TOWN OF WESTWOOD
COMMONWEALTH OF MASSACHUSETTS

Re: Request of Superseding Order
DEP #338-706
Joanne Delapa, Applicant
14 Mill Street, Westwood

SUBJECT: DEP 338-0303 – Review Lot 2B Mill Street
Plan: Proposed Site Plan of Land, Lot 2B Mill Street in Westwood, MA:
Dated: March 9, 2001

Figure 6

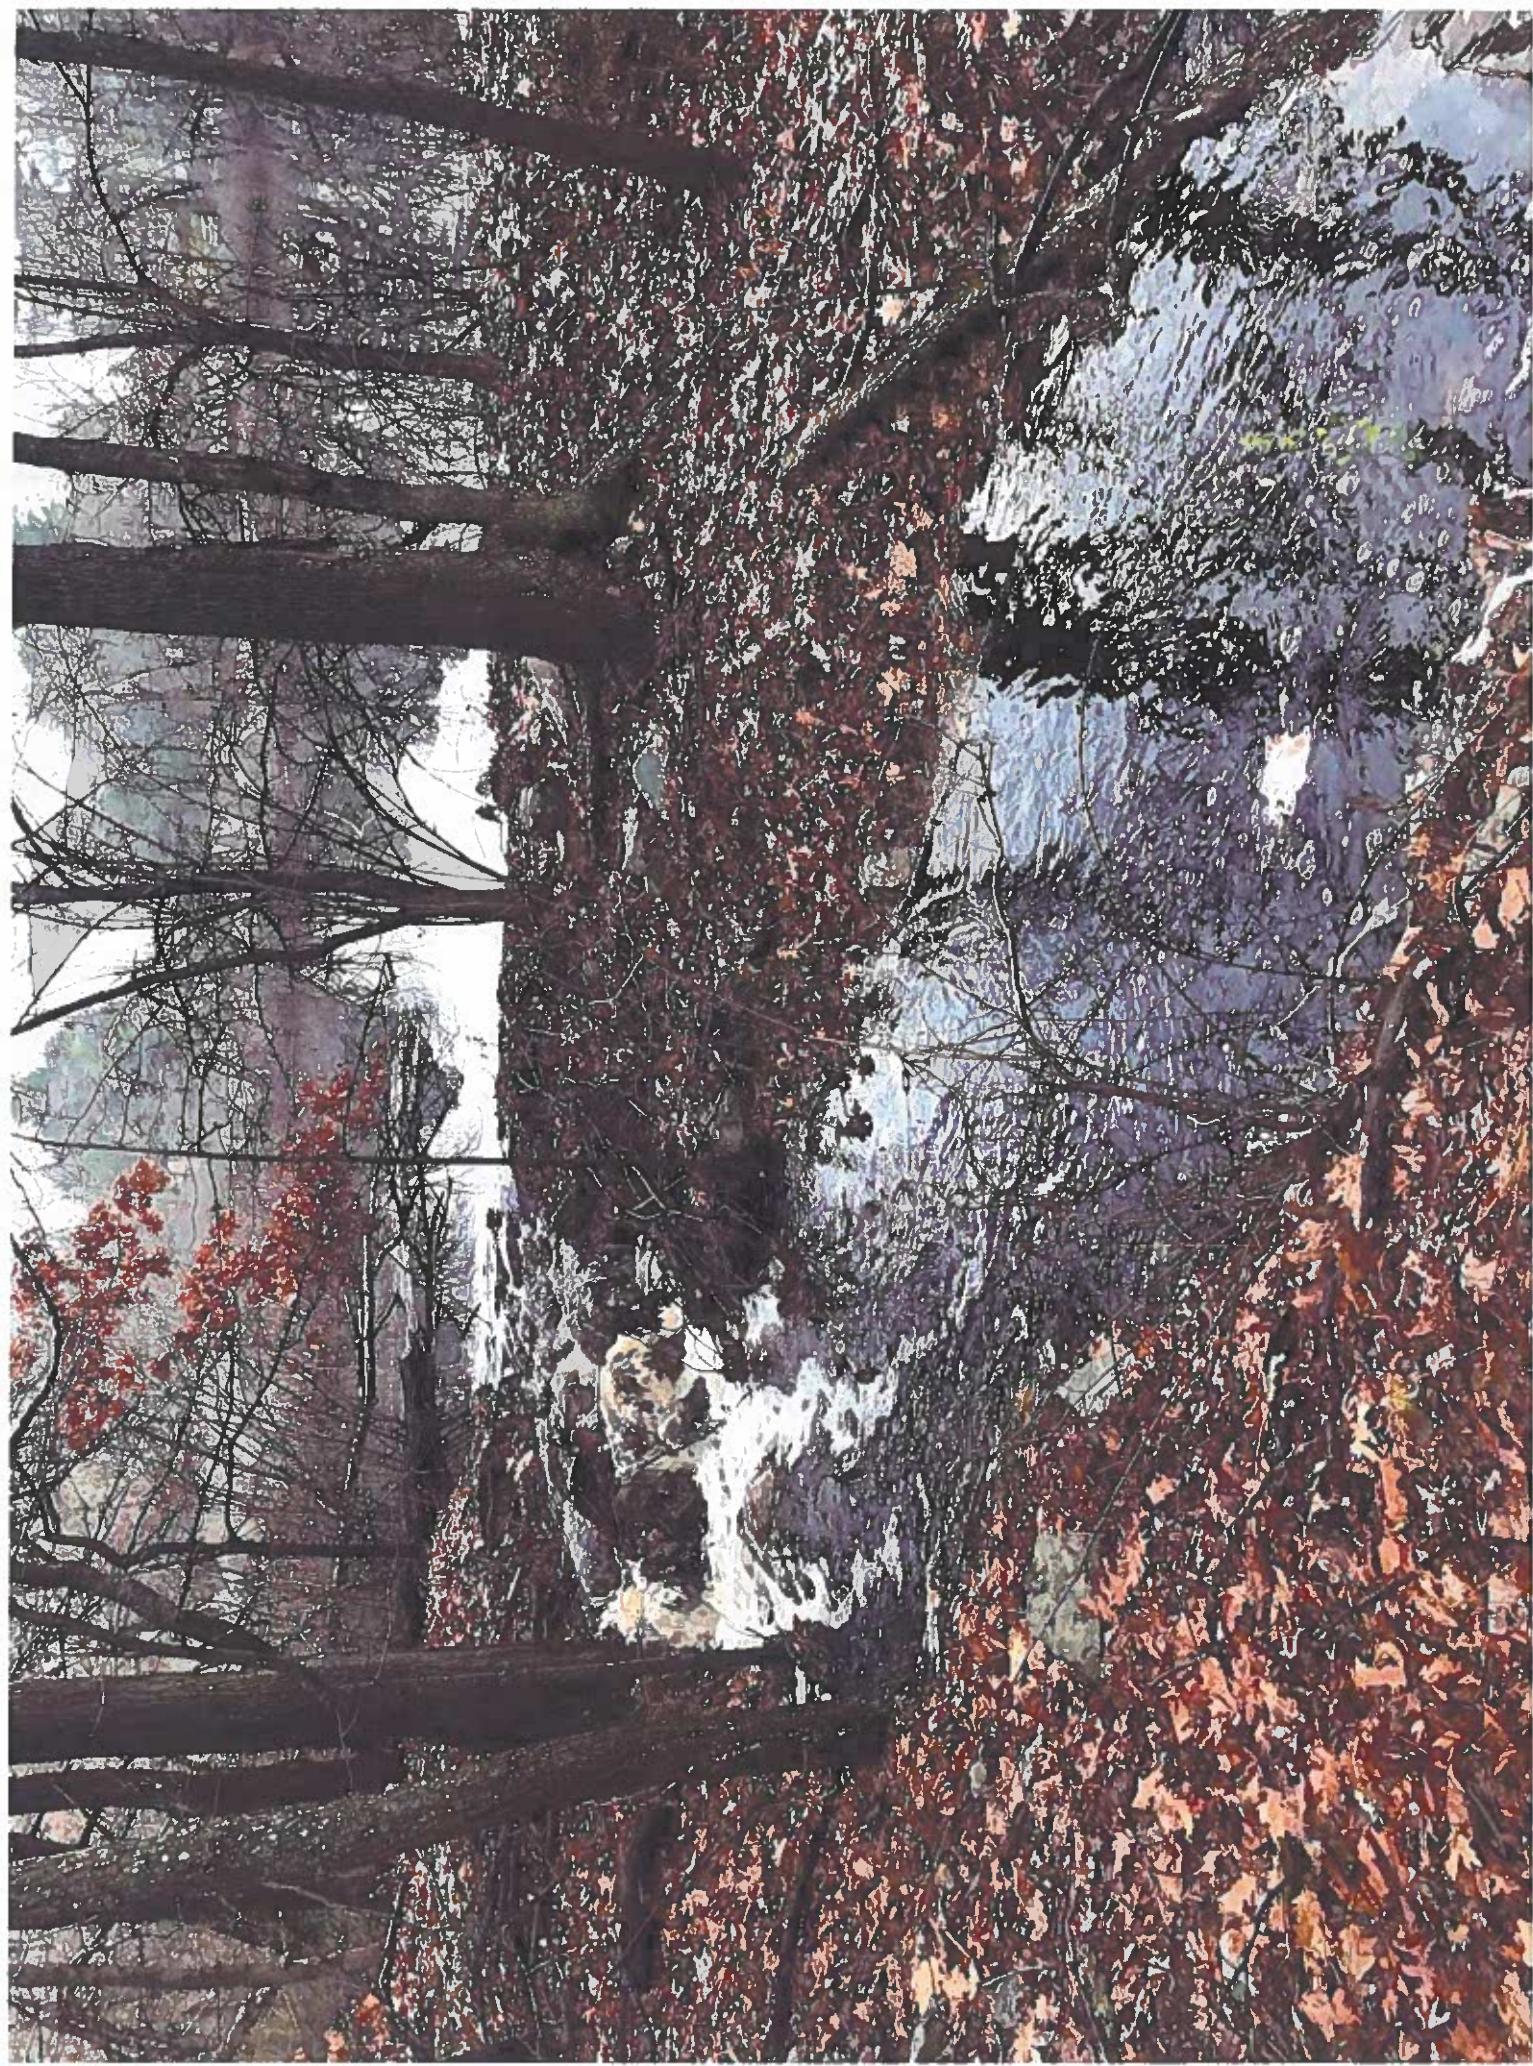
Attachment A is Figure 6 from the original report in January 2016 show the Brook following a channel for more than 140 feet south into the area of the 'pond' and therefore extends the bank of the perennial stream for that distance. The corresponding river front setbacks will also change due to that condition. The second attachment, B, shows the concrete dam and the dry stream channel in October 2020. Debris of the beaver dam can be seen upstream of the concrete dam. Also note the stream channel in the foreground is approximately 35-40 feet wide. The bank of this channel seems to be shown on the submitted plan following contour 184 whereas the channel that was measured is only 5 feet wide. (See Attachment I) This changes the riverfront setback by about 25 feet closer to the proposed house. The third attachment, C, shows the channel flowing at the same time the concrete dam was dry indicating that it now is the likely perennial stream due to the beaver dam. These two photos were taken during an official drought monitoring period. (see attachment G) The fourth photo D, shows the same channel on December 2 2020 after a 2.5 inch rain fall event from December 1. The fifth picture E, shows the same channel looking downstream. Based on this picture the level of the water at the main channel is approximately elevation 188 using the plan of record. This further expands the point of the perennial stream edge, 25 +/- feet closer to the project site because the edge if the perennial stream is the annual high water mark per the regulations. We continue to maintain as well that this stream is the perennial stream due to the changed condition of the beaver dam and the resulting pathway for the water is this channel as documented here. See attachment J. Furthermore based on this information the Commission has the right to consider the pond to not exist if it is not named on the USGS plan and if the characteristic of the steam can be documented through the impoundment.

- A. Figure 6 from original report – indicating the stream channel flows approximately 140 feet through a vegetated wetland before entering the ‘pond’.

U.S. Drought Monitor

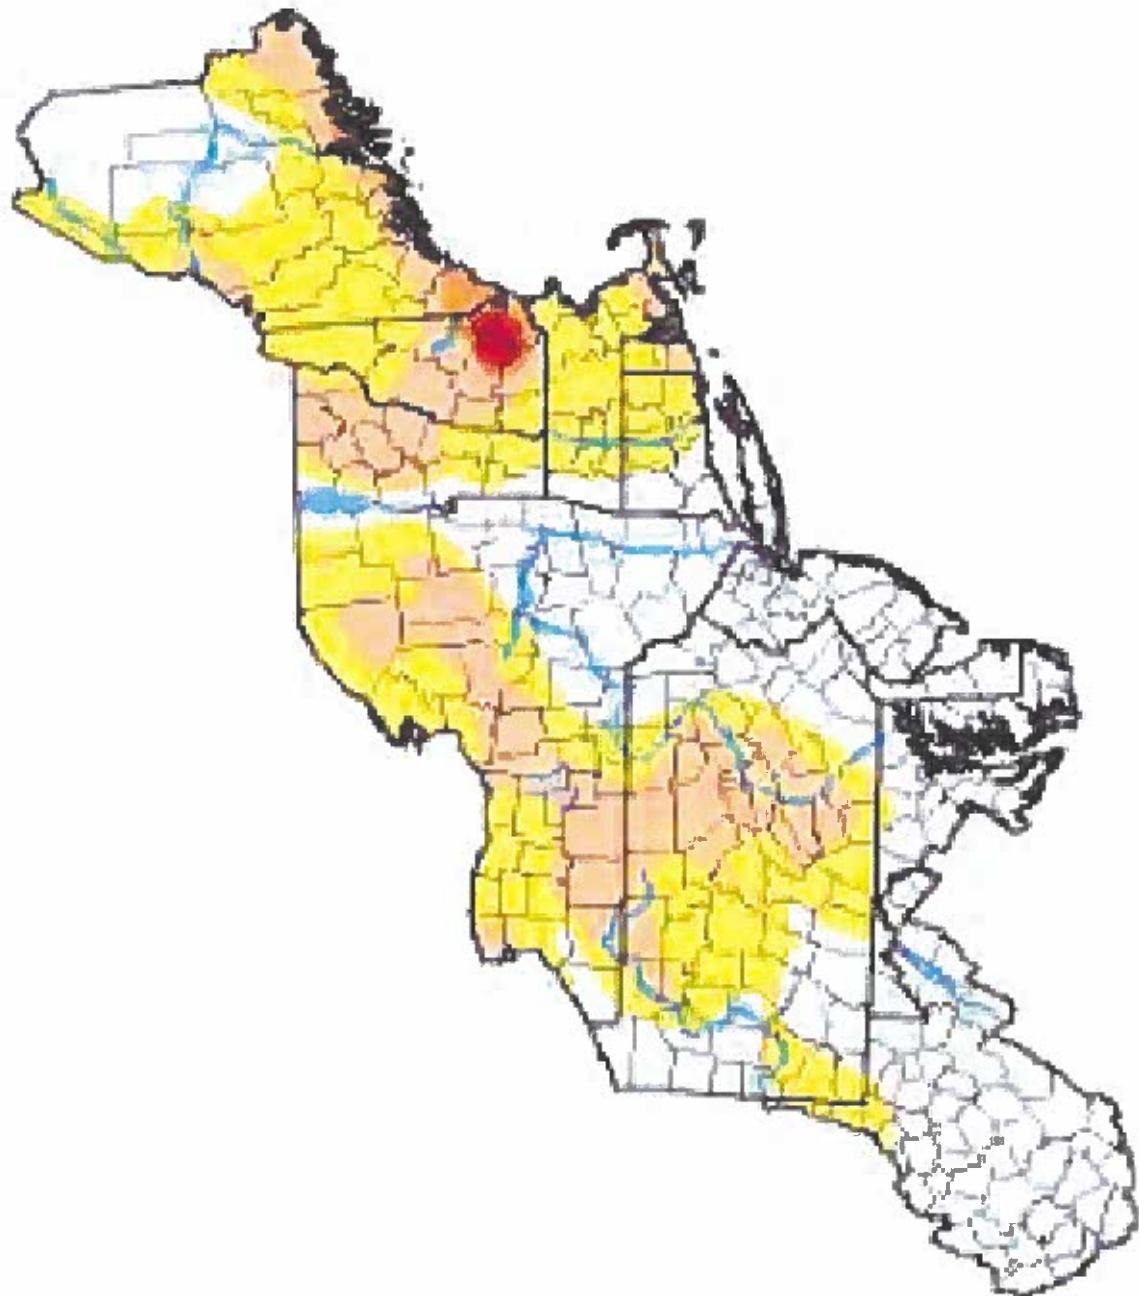
- G. Fall 2020 Drought monitor plan indicating extensive drought condition
- H. Plan of land submitted with application indicating the proposed access location is not from the Right of way but within abutter’s property

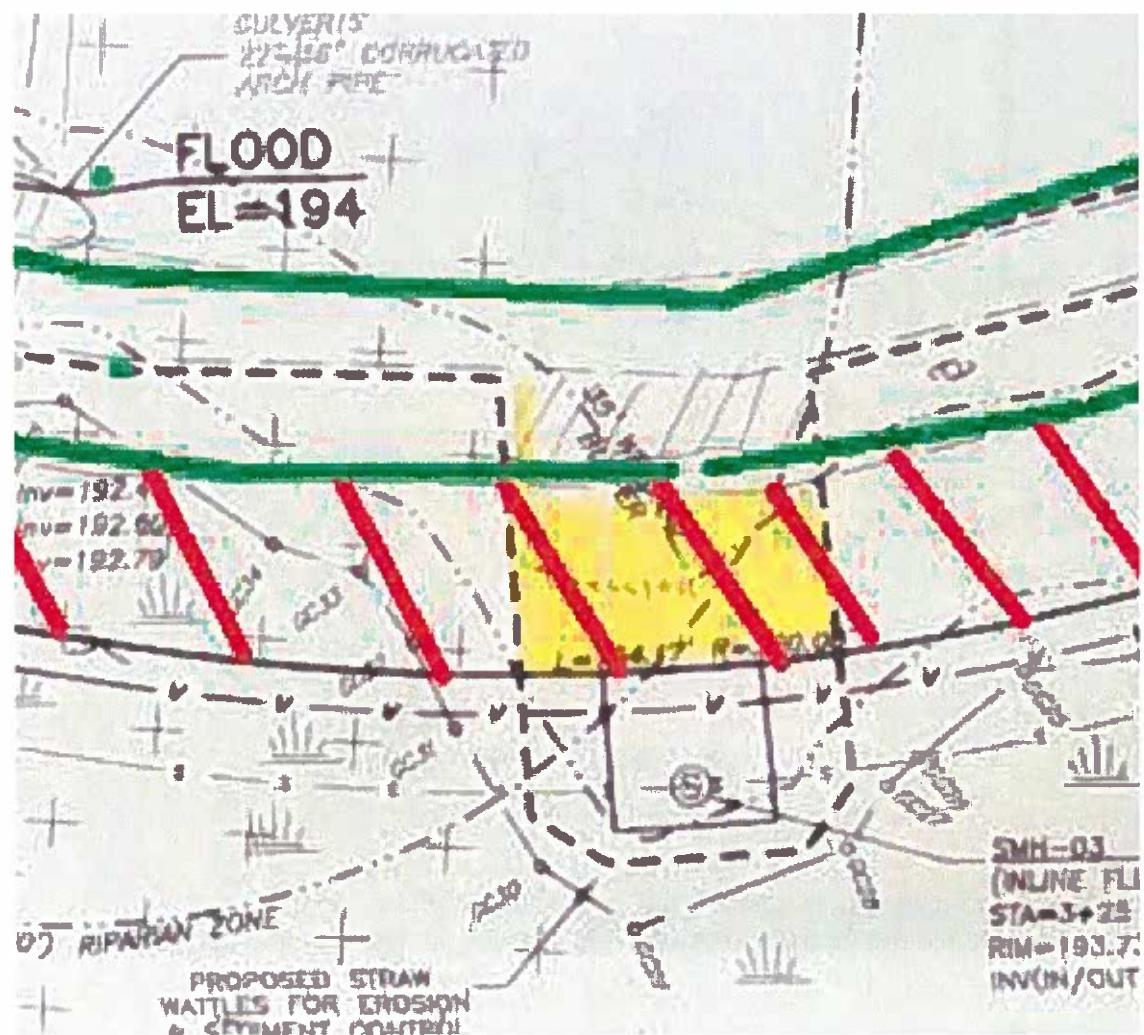
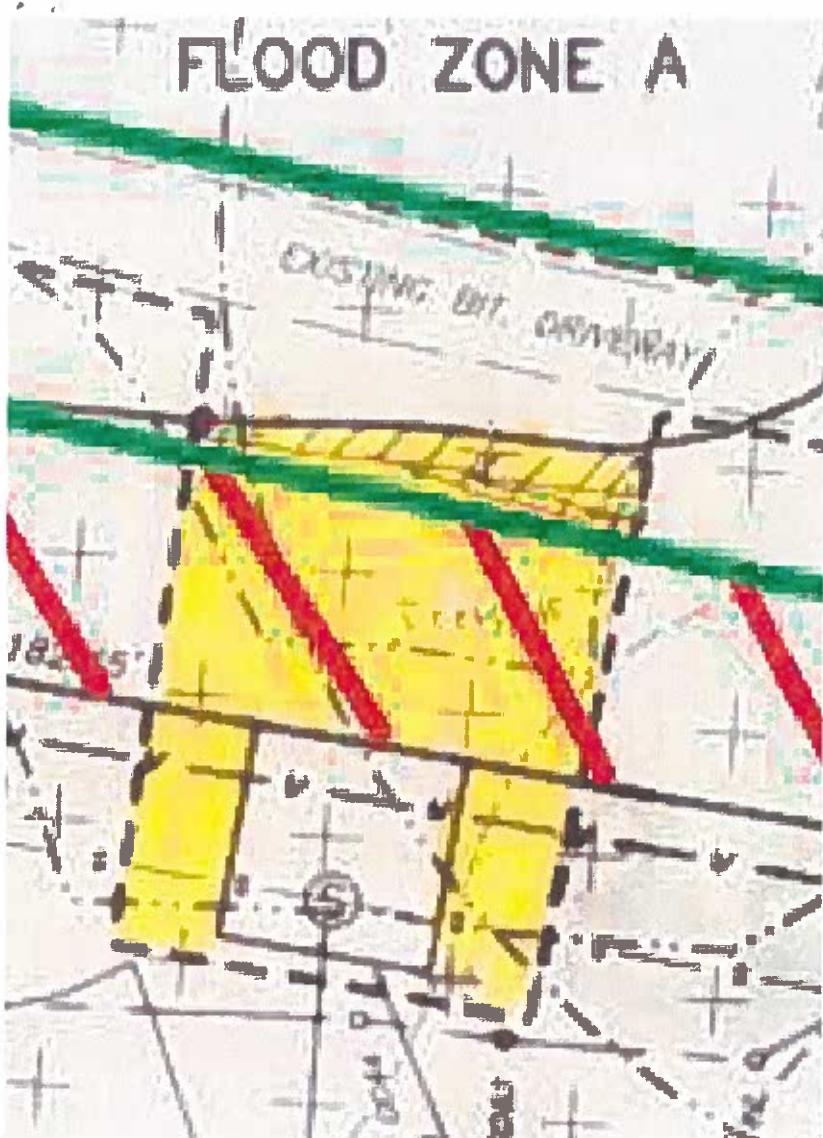
In the next pictures we start running into egregious trespass and destruction of private land..
 Proposed temporary structure 1 would require getting off of the right of way and destroying marked in red lines
 an area on my property to construct temporary structures IN THE WETLANDS.

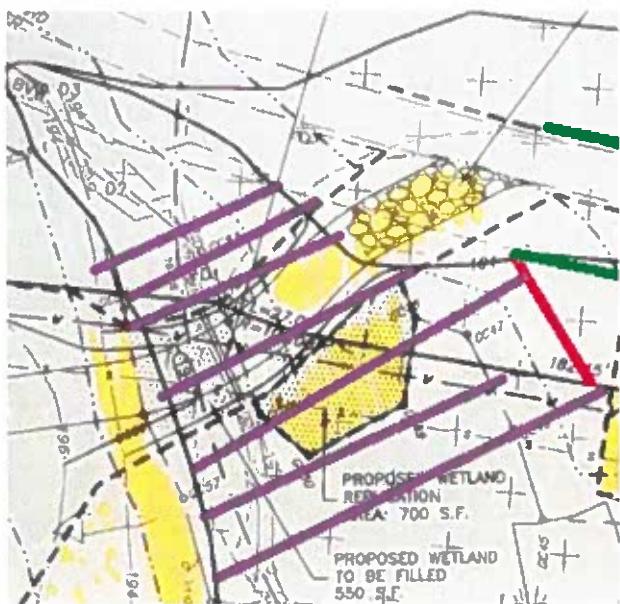
Proposed temporary structure 2 would require getting off of the right of way and destroying marked in red lines an area on my property to construct temporary structures IN THE WETLANDS.

Figure 6

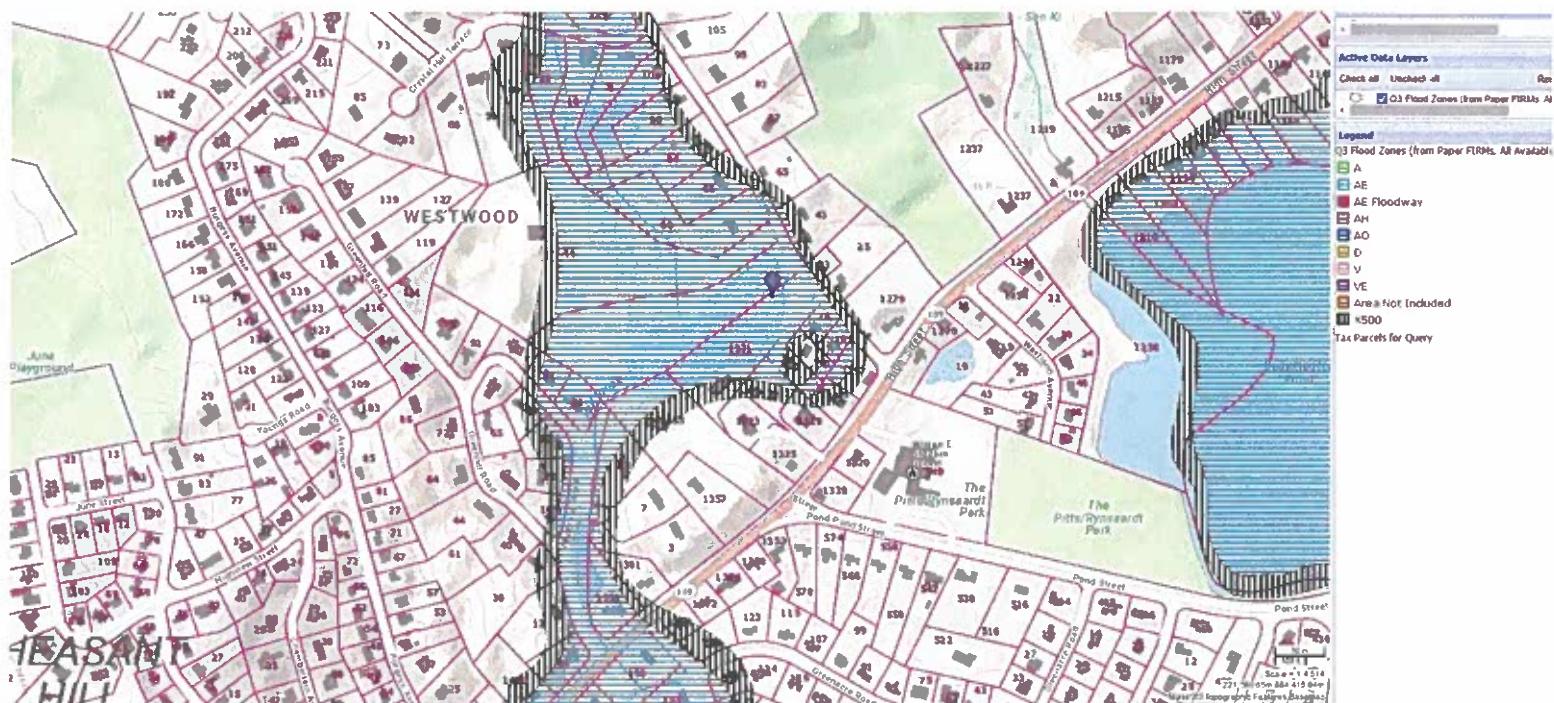
Attachment A is Figure 6 from the original report in January 2016 show the Brook following a channel for more than 140 feet south into the area of the 'pond' and therefore extends the bank of the perennial stream for that distance. The corresponding river front setbacks will also change due to that condition. The second attachment, B, shows the concrete dam and the dry stream channel in October 2020. Debris of the beaver dam can be seen upstream of the concrete dam. Also note the stream channel in the foreground is approximately 35-40 feet wide. The bank of this channel seems to be shown on the submitted plan following contour 184 whereas the channel that was measured is only 5 feet wide. (See Attachment I) This changes the riverfront setback by about 25 feet closer to the proposed house. The third attachment, C, shows the channel flowing at the same time the concrete dam was dry indicating that it now is the likely perennial stream due to the beaver dam. These two photos were taken during an official drought monitoring period. (see attachment G) The fourth photo D, shows the same channel on December 2 2020 after a 2.5 inch rain fall event from December 1. The fifth picture E, shows the same channel looking downstream. Based on this picture the level of the water at the main channel is approximately elevation 188 using the plan of record. This further expands the point of the perennial stream edge, 25 +/- feet closer to the project site because the edge if the perennial stream is the annual high water mark per the regulations. We continue to maintain as well that this stream is the perennial stream due to the changed condition of the beaver dam and the resulting pathway for the water is this channel as documented here. See attachment J. Furthermore based on this information the Commission has the right to consider the pond to not exist if it is not named on the USGS plan and if the characteristic of the steam can be documented through the impoundment. Attachment F is the latest FEMA flood map for the 100- and 500- year elevations from the MASS GIS system. Note that the entire site is within the 100 year flood plain including the house location. In fact the entire lot as shown is within the 100 year flood plain.

- A. Figure 6 from original report – indicating the stream channel flows approximately 140 feet through a vegetated wetland before entering the ‘pond’.

U.S. Drought Monitor

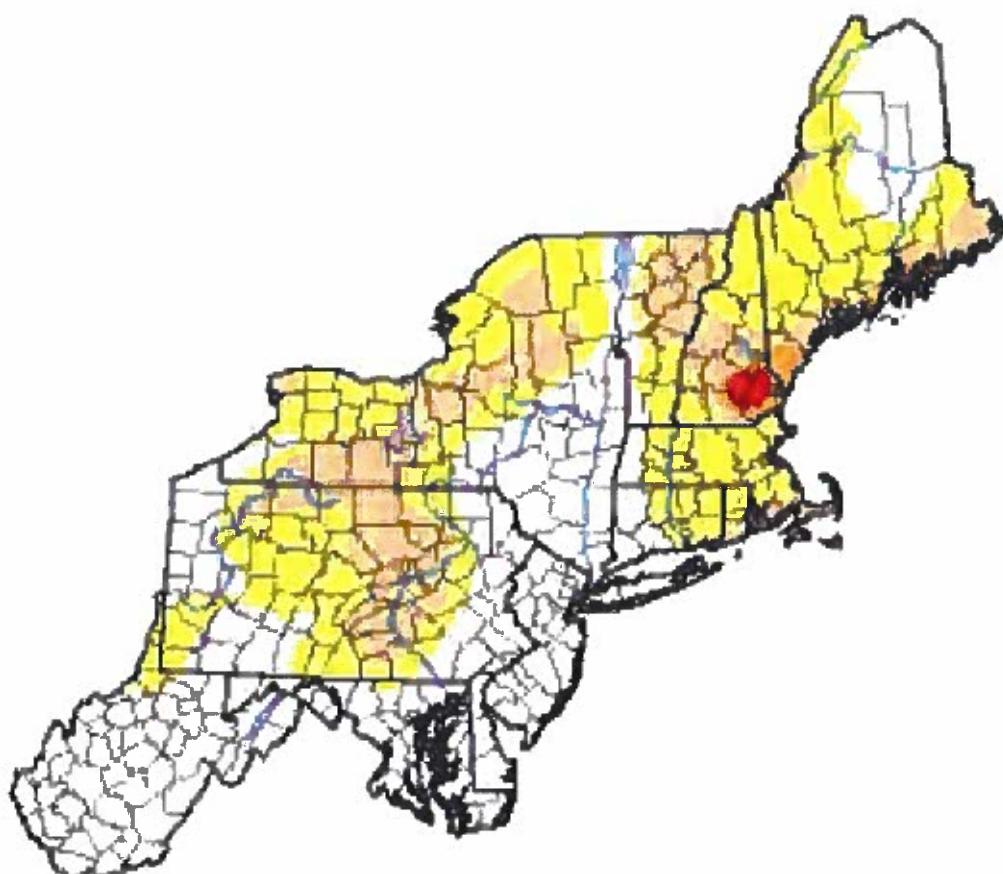
- G. Fall 2020 Drought monitor plan indicating extensive drought condition
- H. Plan of land submitted with application indicating the proposed access location is not from the Right of way but within abutter’s property
